CITY OF AUSTIN – DEVELOPMENT SERVICES DEPARTMENT  
SITE PLAN APPLICATION – MASTER COMMENT REPORT

CASE NUMBER: SP-2019-0210C  
REVISION #: 00 UPDATE: U3  
CASE MANAGER: Robert Anderson PHONE #: 512-974-3026

PROJECT NAME: 1400 W Oltorf St  
LOCATION: 1400 W OLTORF ST W/UNITS

SUBMITTAL DATE: June 17, 2021  
REPORT DUE DATE: July 2, 2021  
FINAL REPORT DATE: July 2, 2021

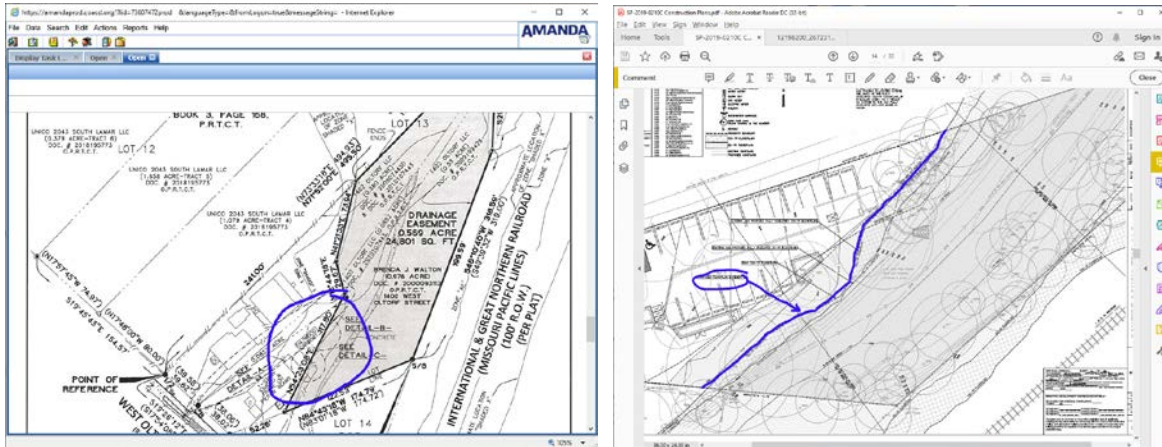
**UPDATE 3: Pending. When easement has been dedicated, update the relevant plan set pages with easement document number. Only the metes and bounds was provided as "drainage easement," unfortunately, metes and bounds do not a drainage easement make. Because there is building overhang into the easement, the most appropriate easement template to use is likely the "With Permitted Obstructions" version (also, please add**

building overhang to the floodplain page so it is clear where the building overhangs into the easement). Additionally, the metes and bounds provided do not match the proposed easement as indicated on the plan set; notice how the easement metes and bounds provide a straight line in the circled area, but the site plan shows a non-straight line (see below). Provide updated metes/bounds and easement document, or update site plan page to match metes and bounds document:

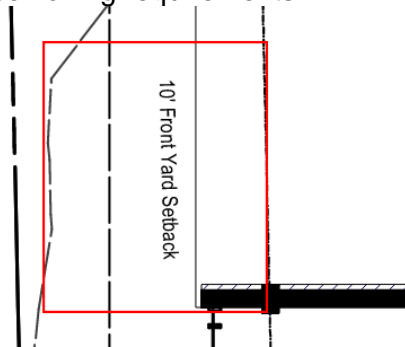
SP56. The landscape sheet is new to this update. Please remove the text indicating a 10 foot front yard setback. While CS zoning districts have a 10 foot front yard setback, Subchapter E supersedes base zoning requirements.

**Update 3: Comment remains.**

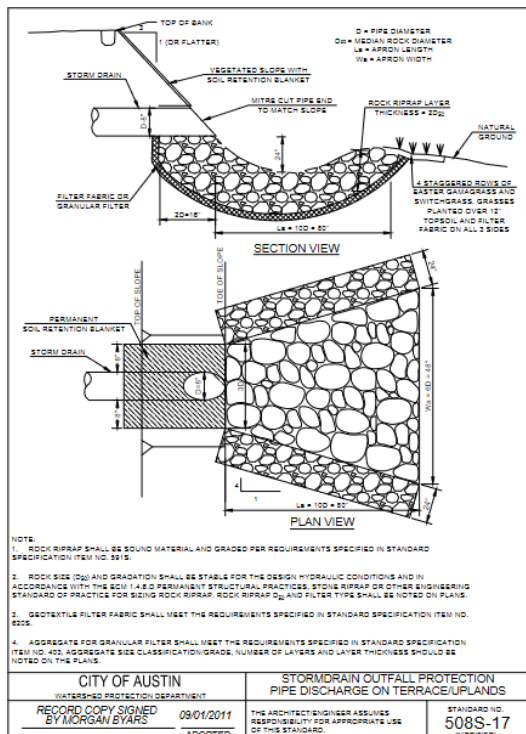
WETL 4. **Update 3** Please modify the outfall of the detention pond to form a armored stilling basin per the following detail (this reviewer can provide a pdf or dwg upon request (ana.gonzalez@austintexas.gov)
